## Product Change Notification / SYST-21DFRY755

ERRATA - PIC18(L)F24/25K42 Silicon Errata and Data Sheet Clarification Errata Document Revision

## PIC18(L)F24/25K42 Silicon Errata and Data Sheet Clarification

Figure 44-5 Clock Timing

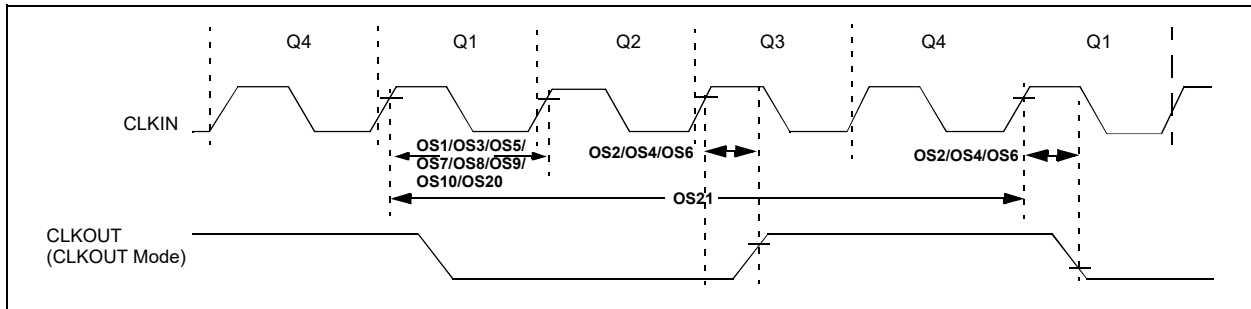
Figure 44-5 incorrectly shows the location of parameters OS1, OS2, OS3, OS4, OS5, OS6, OS7, OS8, OS9, OS10, OS20 and OS21. The correct location for the above-mentioned parameters is depicted in the following figure.
